**BLUE MARSH LAKE,**

*Bernville Protective Works.*

**DESIGN MEMORANDUM NO. 13**

**BERNVILLE PROTECTIVE WORKS**

SHEET NO. 10 OF 25  
JOB NO. \_\_\_\_\_

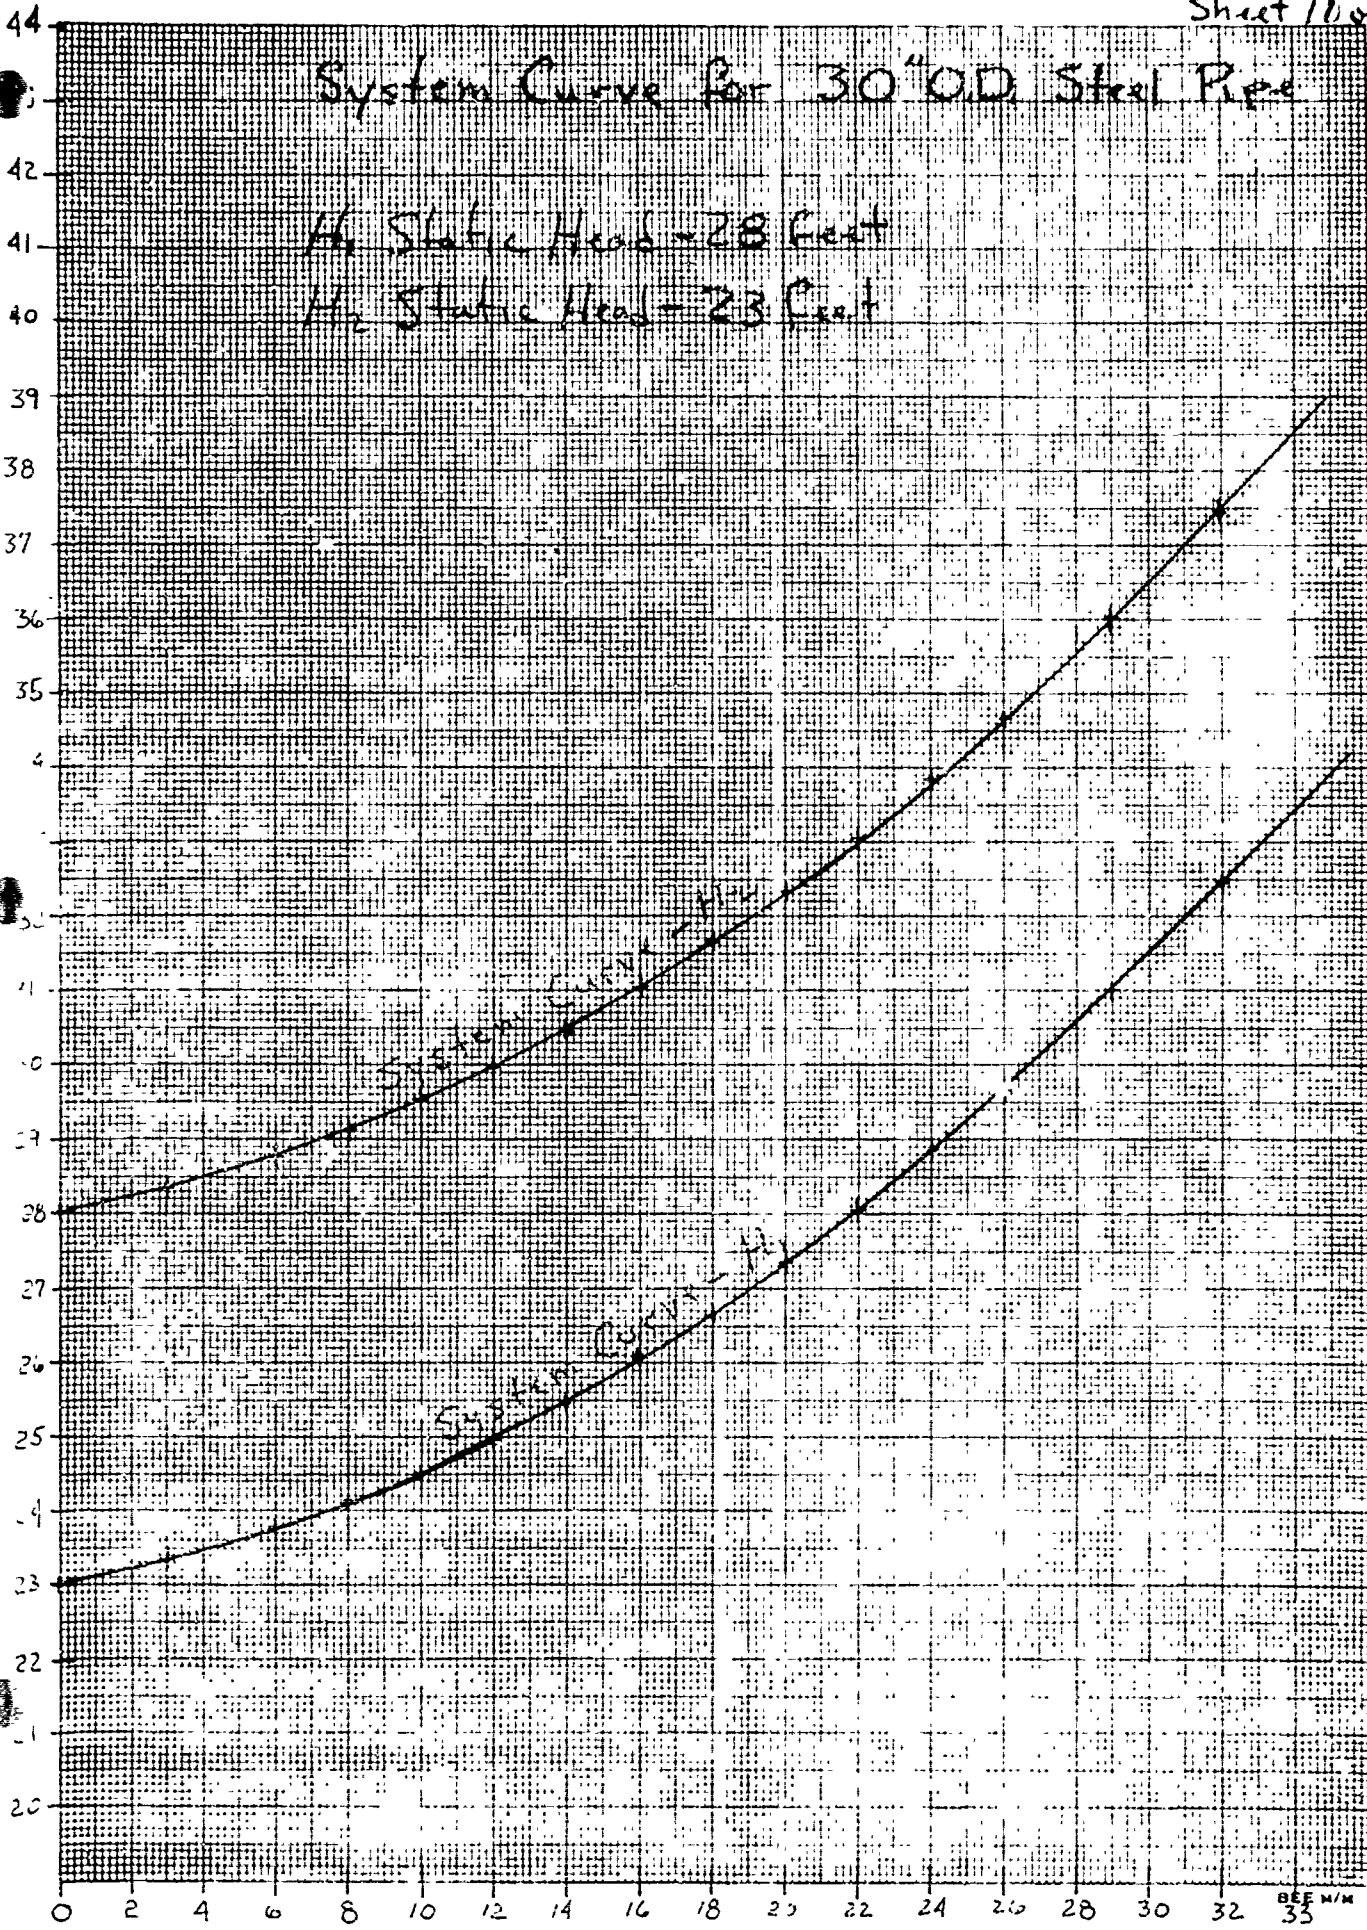
b. Sheet No. 5, Friction losses in the discharge line should be determined using the formula given in paragraph 9c (2) of EM 1110-2-3105.

c. Sheet No. 6, Miter bend losses in the discharge line (2 bends) should be determined using a value of K obtained from the curve ( $Re=2 \times 10^4$ ) on WES Hydraulic Design Chart 228-2/1.
